CITY OF ALBUQUERQUE

Re: Uptown Hotel
2444 Louisiana Blvd. NE
Traffic Circulation Layout
 Engineer's Stamp XX-XX-XX (H19-D093)
 TRANS-2025-00095

Based upon the information provided in your submittal received 04-21-25, the above referenced plan cannot be approved for Building Permit until the following comments are addressed:

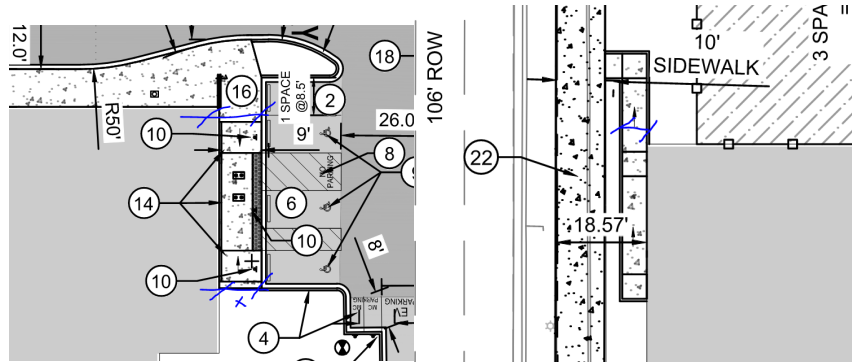
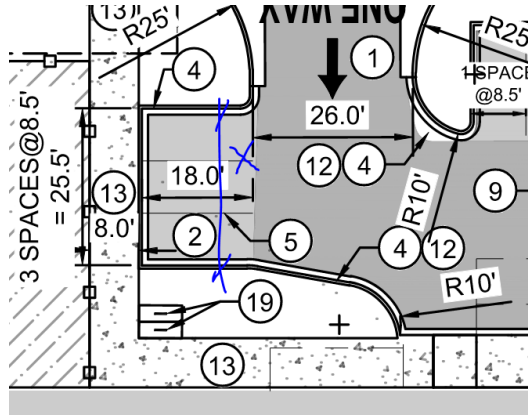
3. Is the proposed sidewalk off Louisiana Blvd and Prospect Pl within the private property? If so, then a sidewalk easement is required.
4. Please show on the site plan the Hotel Building entrance.
5. Please clearly show on the site plan these dimensions:

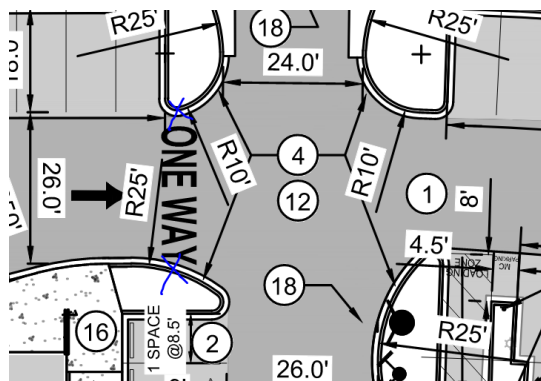
6. How wide are these parking spaces?

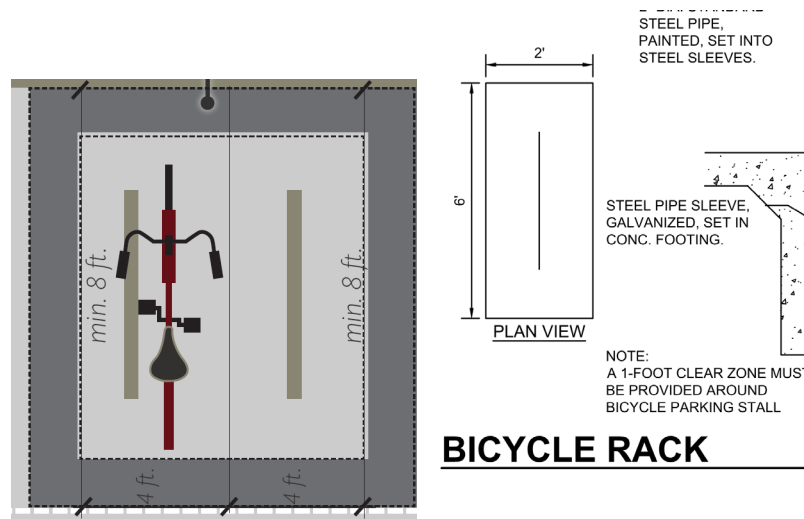
7. Please provide "STOP" & "DO NOT ENTER" signage at this one-way location.
